5					4					3					2					1																			
MODEL:					REV:					CHANGE LIST:															MODEL					ZU1									
ZU1 FUNCTION BOARD					1A					FIRST RELEASE															PAGE					FROM					TO				
					1B					PLEASE REFER TO ECN E200611-0701															1					1A					1B

PROJECT : ZU1

Size	Document Number	Rev 1B
	SWITCH,MR SENSOR	
Date:	Friday, December 15, 2006	Sheet 1 of 1

Hall IC & MR SENSOR(Magnetic Lid Switch)

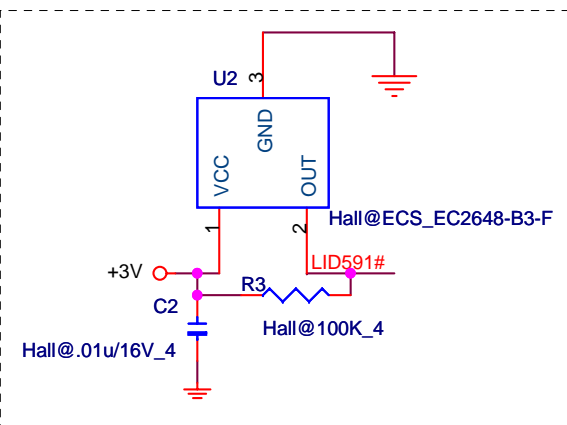
A1A: (10/31) Delete +3VPCU

A1A: (10/26) Add Hall IC function.

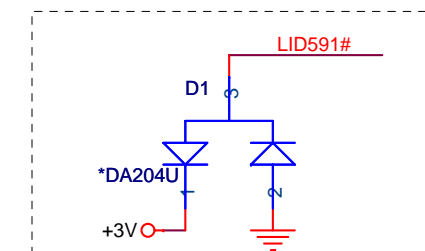
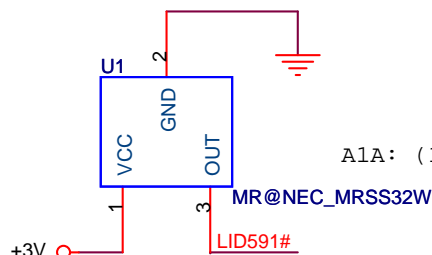
A1A: (10/30) Add ESD protection for MR sensor.

Launch Manager

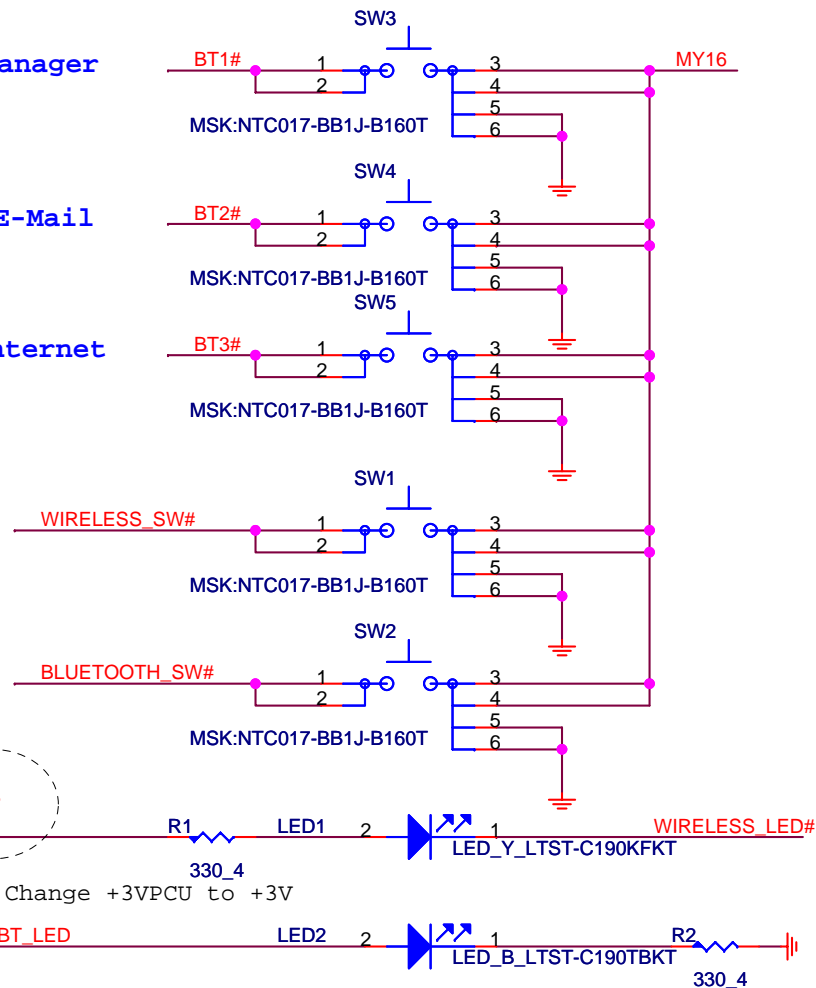
A1A: (10/30) Change +3VPCU to +3V

A1A: (10/24) Delete Email LED
